Committee of the Whole Report

For the Meeting of July 11, 2024

Subject: **Update on Rezoning Application No. 00804 for 205 Quebec Street, 507 Montreal Street, and 210-224 Kingston Street and associated Official Community Plan Amendment and Development Permit with Variances Application No. 00191**

Figure 1. Comparative Massing

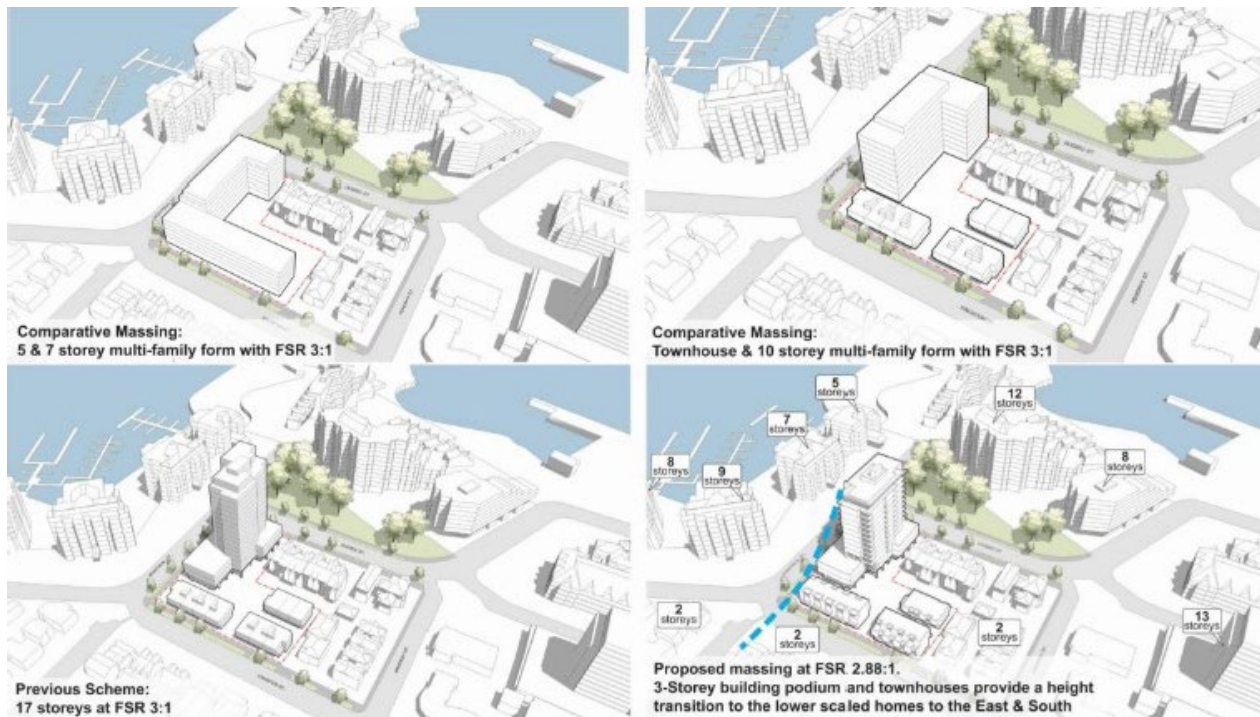
The applicant considered various building massing and siting options in response to the Council motion (see Comparative Massing below) but decided to maintain a similar proposal with a reduced height. They provided a Height and Massing Rationale which is included with their letter to Mayor and Council attached to this report. Staff believe that it would likely be easier for the applicant to design a proposal to be more consistent with City policies by exploring different massing, such as an approximately six-storey building towards the north end of the site and lower scale buildings towards the south, however, it would likely be challenging to retain the density of the previous proposal with this approach, which is one of the goals of the previous Council motion.
